**** MANDATORY ****
SERVICE BULLETIN

SUBJECT: GRS 77 AHRS (Attitude and Heading Reference System) Mod 1

SB07-34-06

GARMIN G1000 GRS-77 ATTITUDE AND HEADING REFERENCE SYSTEM (AHRS)
INSPECTION/REPLACEMENT

Figure 1. AHRS Inspection/Replacement (Sheet 1)

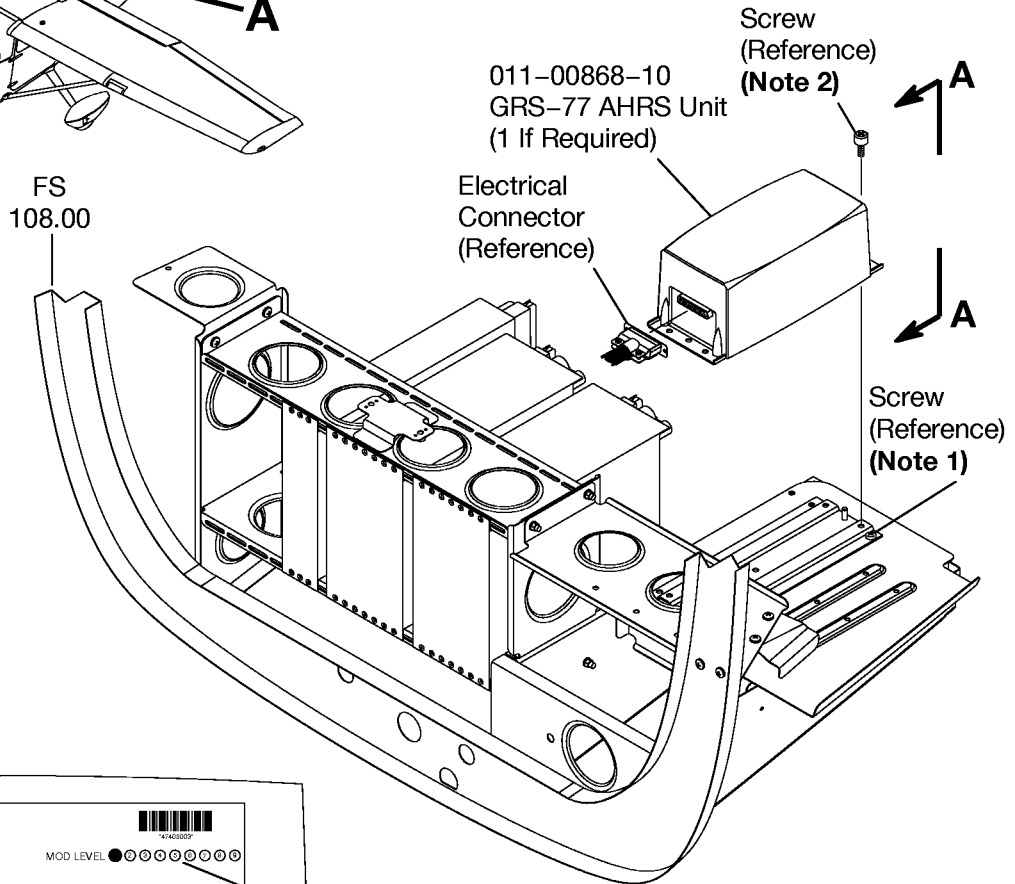
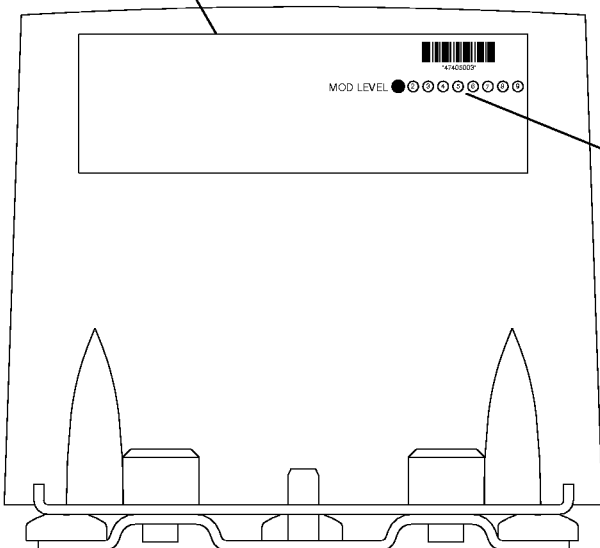
6. (Refer to Figure 1, Detail A.) Remove the GRS-77 AHRS unit from the airplane. (Refer to the applicable maintenance manual, Chapter 34, Attitude Heading Reference System (AHRS) - Maintenance Practices.)

- C. Remove the GRS-77 AHRS unit from the airplane.
7. (Refer to Figure 1, View A-A.) Identify the mod level of the GRS-77 AHRS unit installed in your airplane:

- A. Find the identification plate on the top front of the GRS-77 AHRS unit.
 - B. See if the mod level of the GRS-77 AHRS unit installed in your airplane is MOD 1:

- (2) If the mod level shown on the identification plate is MOD 0, you must replace the AHRS unit with a serviceable 011-00868-10 GRS-77 AHRS Unit with MOD 1 or a later mod level as follows: (Refer to the applicable maintenance manual, Chapter 34, Attitude Heading Reference System (AHRS) - Maintenance Practices.)

NOTE 2: Loosen these screws to remove the GRS-77 AHRS unit.

NOTE 3: If the mod level shown on the identification plate is MOD 1 or later, no GRS-77 AHRS unit replacement is necessary.
